TX-RX UNIT (X57-586X-XX) Foil side view

## Cross-Band Modification

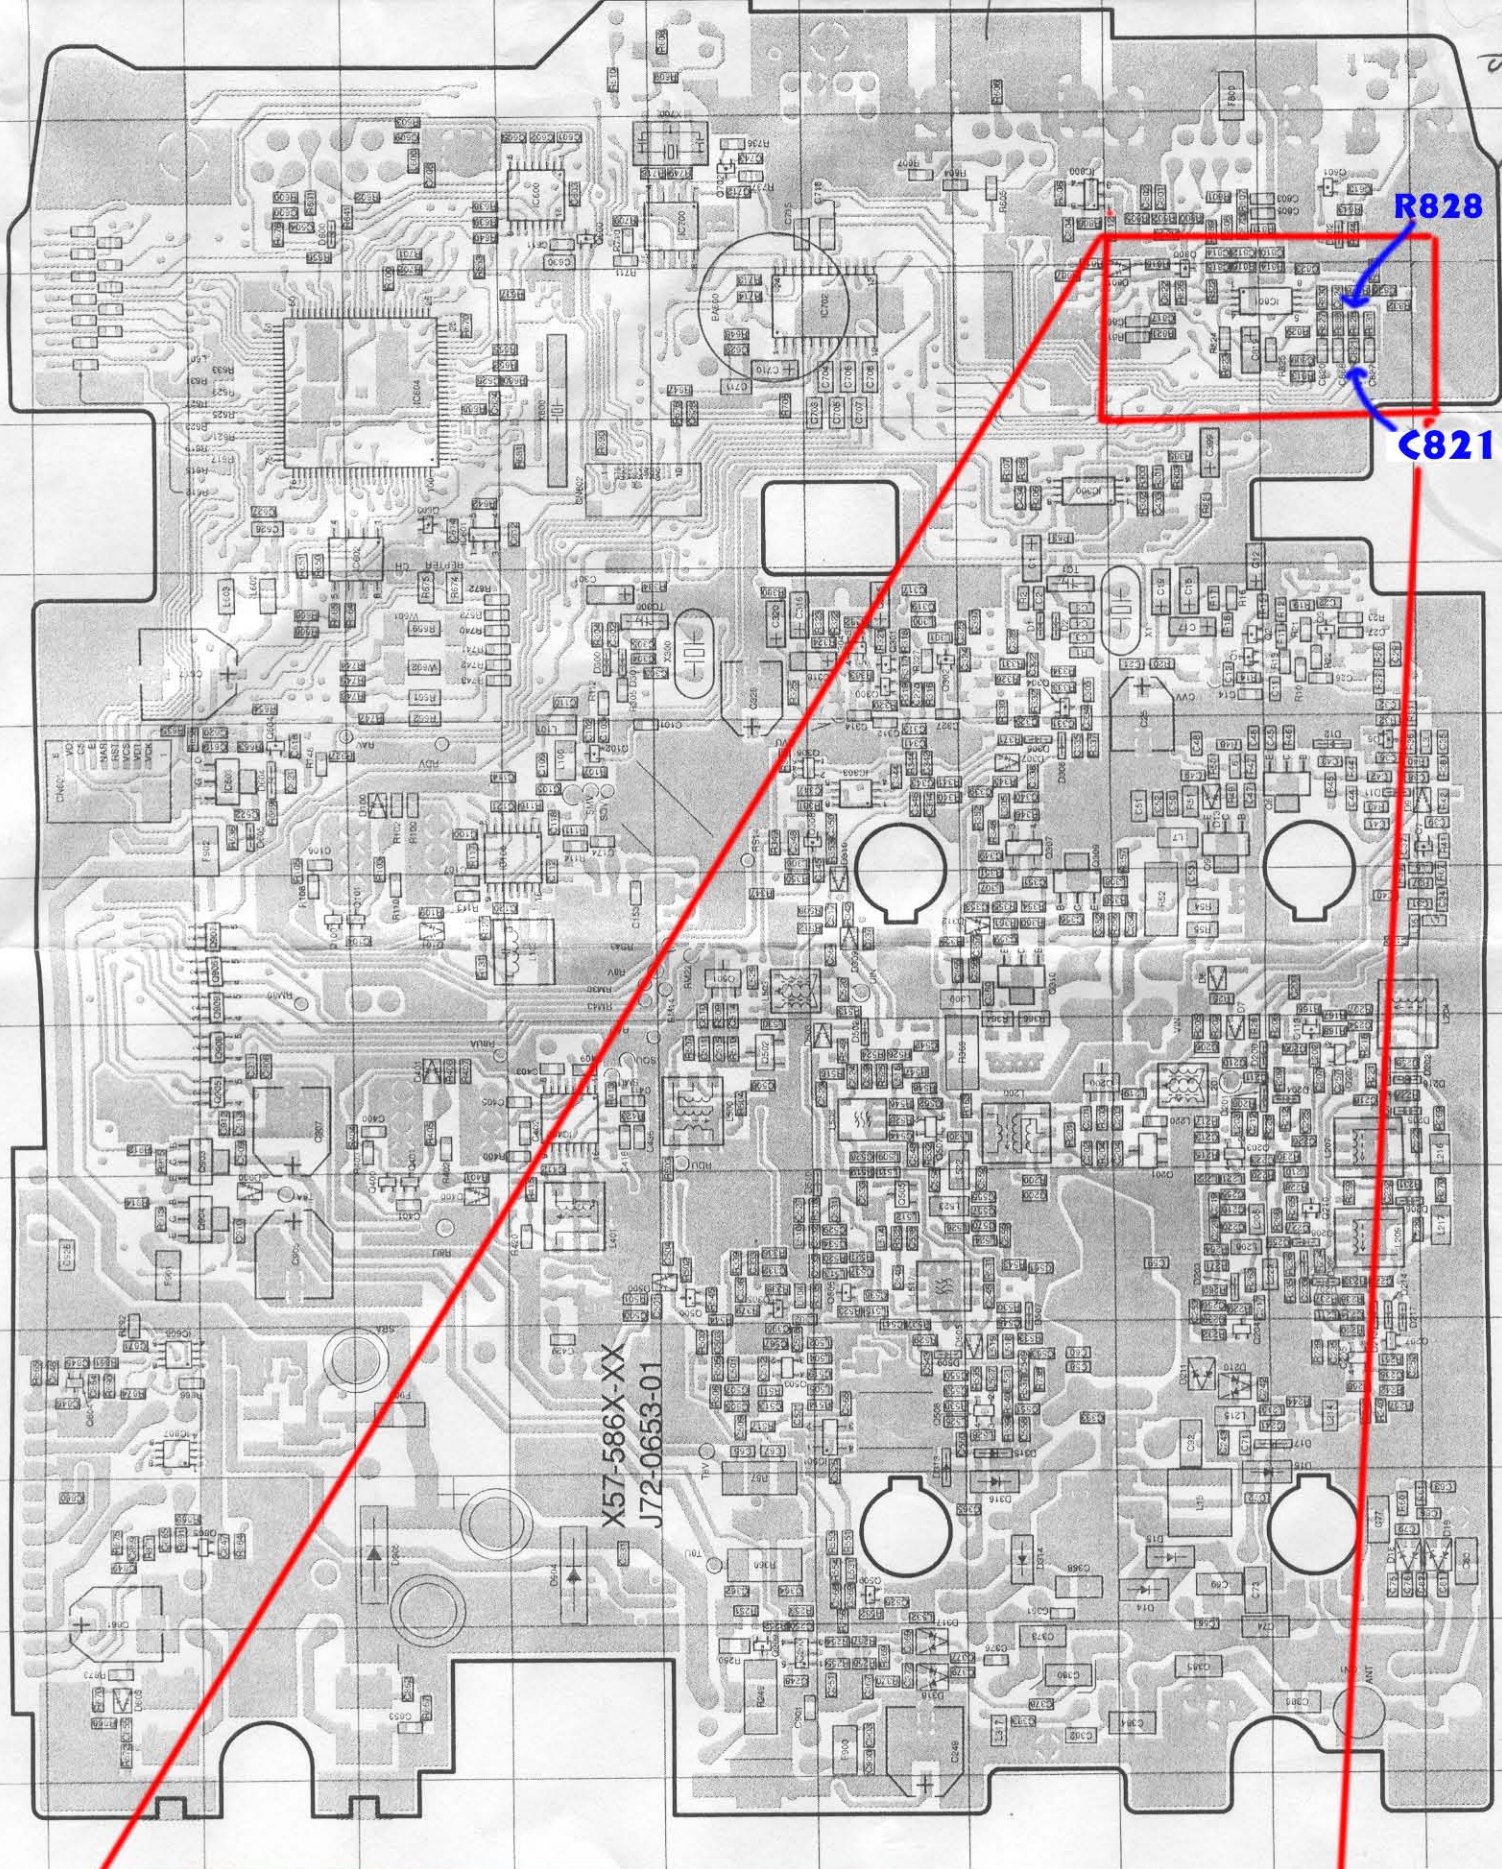
~~Change C821 to 0.022uF~~

~~Change R828 to 22K~~

This modification will fix the over deviated/muffled transmitted audio while using the Cross-Band Repeater
